Light Scattering and Baffle Configuration for LIGO (Report Prepared for LIGO Baffle Review, 6&7 January 1995)

(LIGO Technical Report LIGO-T950101-00-R)

Eanna E. Flanagan and Kip S. Thorne

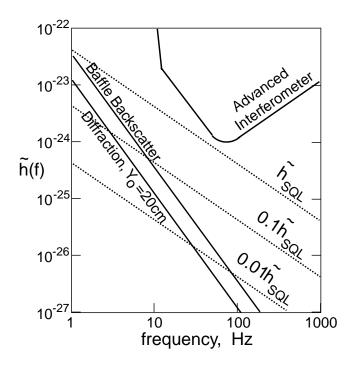
Figure 2 compares this goal with our best estimates of the two dominant noise sources [baffle backscatter, and baffle diffraction with off-centered mirrors, Eqs. (2) and (7) below] for the current baffle design, assuming no amplification of ground motion by normal-mode vibrations of the beam tube. The diffraction noise satisfies our suggested $0.1h_{SQL}$ goal, with nearly a factor 10 safety margin for vibrational amplification plus calculational inaccuracies (if, as we assume in Fig. 2, coherence effects are adequately controlled for centered mirrors by making the baffle serrations random; our Suggestion 5). However, we would feel a little more secure if unnecessary baffles were removed, thereby reducing the off-center diffraction noise by $\sqrt{2}$. The backscatter noise leaves no margin at 10 Hz for vibrational amplification or calculational inaccuracies. Thus, we regard as quite important our Suggestion 2, to change the baffle material to something like Martin Black, thereby reducing the backscatter noise by about a factor $\sqrt{10}$.

For the parameter values shown in Eq. (2), this baffle backscatter noise has the values plotted in Fig. 2, and is $\tilde{h}_{\rm baf\ bkst} = 0.08(10 {\rm Hz}/f) \tilde{h}_{\rm SQL}$. By changing the baffle material from beam-tube steel to Martin black, β would be reduced by a factor 10 and $\tilde{h}_{\rm baf\ bkst}$ would be reduced by a factor $\sqrt{10} \simeq 3$.

Suggestion 2: Change the baffle material from the same oxidized steel as the walls are made of, to Martin Black or some other material with a comparably low backscatter probability. This would lower the backscatter noise by a factor $\simeq 3$. See Backscatter [11] for detailed justification.

FIG. 3. Diagram, in the plane of baffle n, depicting the geometry used in a phase-coherent computation of diffraction noise.

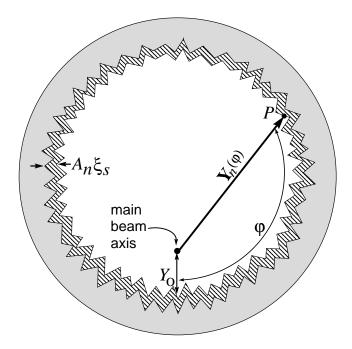
of all light that passes through the cross-hatched region in the baffle plane of Fig. 3, which has been opened up by the baffle's radial vibrational displacement $A_n(\varphi,t)\xi_s(t)$. (Here A_n is the factor by which the seismic noise ξ_s is amplified at location φ and time t on baffle n.) This explains the integration element $RA_n\xi_sd\varphi$, which represents the area of the cross-hatched region between φ and $\varphi + d\varphi$. As the baffle vibrates, the cross-hatched region changes size and shape, thereby changing the scattered light field $\delta \psi_{\rm mb}$ being added to the main beam; this is the origin of the phase modulation that mimics the gravitational wave.

FIG. 4. The pattern of Fresnel zones around the main beam axis, corresponding to the transverse phase factor (5) in formula (4) for baffle diffraction noise.

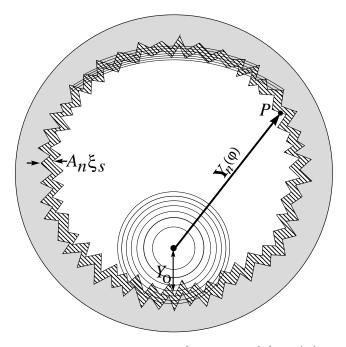
If the mirrors are displaced a distance $\gg \sqrt{\lambda L} = 4.5$ cm from the beam tube center (as in Figs. 3 and 4), then the Fresnel zone pattern will be substantially offset from the averaged (smoothed) beam tube edge. There then will be near cancellations of the diffraction-noise contributions from adjacent Fresnel zones, and these near cancellations—even in the absence of baffle serrations will make the scattering noise essentially incoherent. A quantitative analysis based on Eq. (4) shows in this case that the baffle serration neither helps nor hurts; the noise is essentially independent of whether the baffles are serrated and whether the serrations are regular or random; see Sec. IV.A.5 of Kip's original scattering report [1] for details. By performing the integral and sums in (4) for the case of no baffle serrations, we obtain the following expression for the diffraction noise:
